**OVERVIEW**

This document outlines errata for the ADXL317 C-samples (also known as C-silicon), based on the ADXL317 datasheet revision 0 and expected functional performance. The C-sample material is intended to follow the functionality as defined in the ADI datasheet specification Rev 0.

**ERRATA ITEM #1: SENSITIVITY VALUES**

Figure 1. Current Figure 39 in ADXL317 Datasheet Rev 0 (Incorrect)

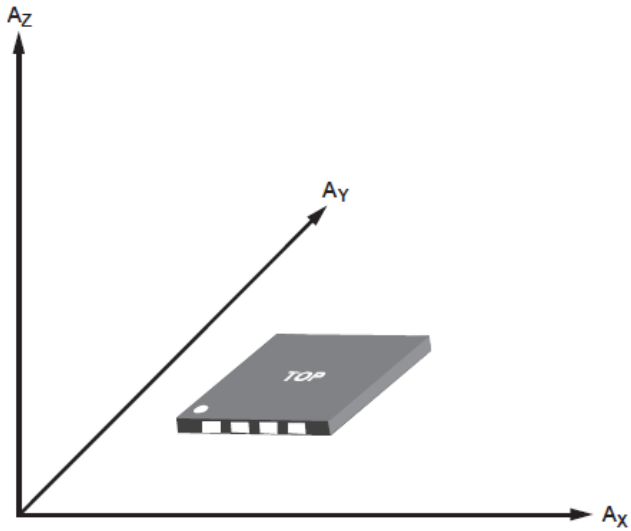
**ERRATA ITEM #2: PIN 1 INDICATOR ON FIGURE 39**

Figure 39 in the datasheet Rev 0 shows the pin 1 indicator in the wrong location. This will be fixed in the next revision of the datasheet.
